Subject: Fuel Leak Case RO0000117, 1532 Peralta Street, Oakland, CA 94607

Alameda County Environmental Health (ACEH) staff has reviewed the case file for the subject site including the January 31, 2007 Soil and Water Delineation Work Plan. The work plan responds to the County's 11/29/06 letter. We have the following technical comments we request you address when performing the proposed work.

PROPOSED INVESTIGATION ACTIVITIES
 1532 Peralta Street, Oakland, California

Figure 17

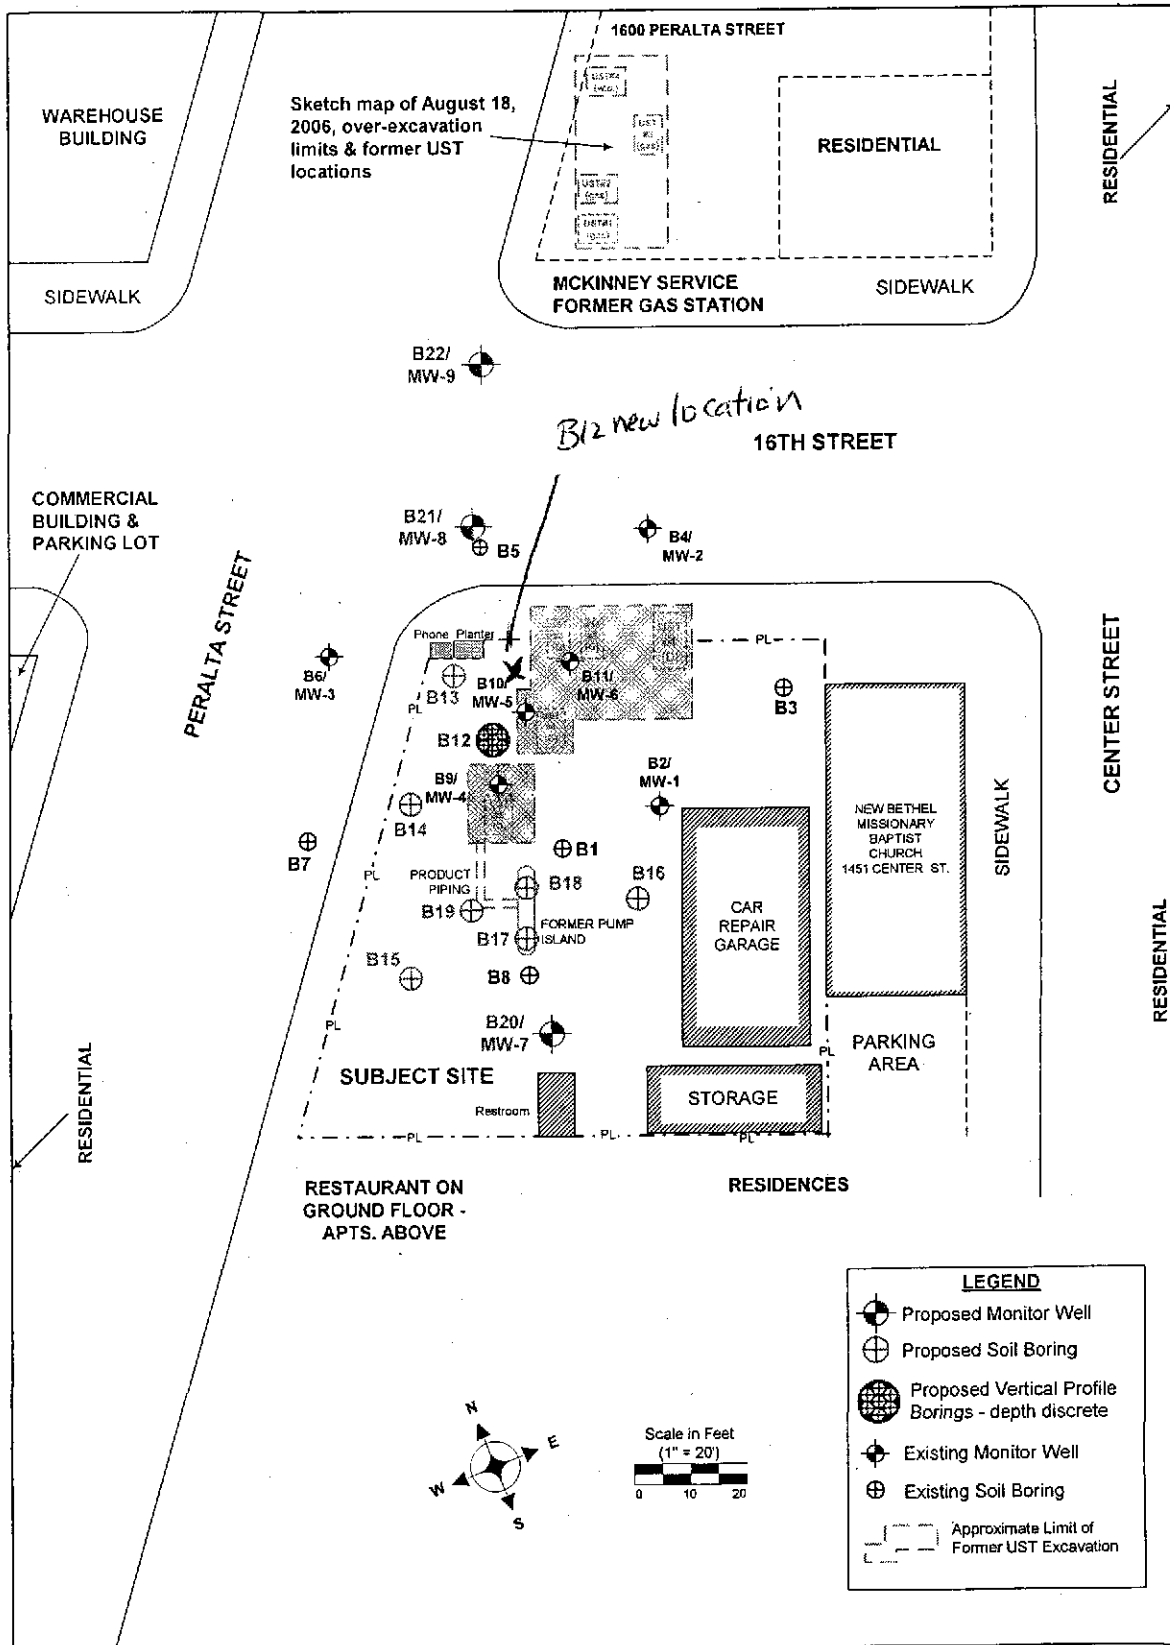
- The vertical profiling of groundwater contamination is proposed for characterization by drilling a deep Geoprobe boring, B12, to 40' bgs. The lithology will be continuously logged and soil samples collected every five feet, at zones of apparent water bearing capacity and obvious areas of contamination. Using this data, additional clustered hydropunch borings and depth discrete water samples collected from the zones of interest. We approve this proposal with the condition that B12 be moved to be located down-gradient of MW-5. See the attached figure for the recommended location.

Enclosure: revised Figure 17
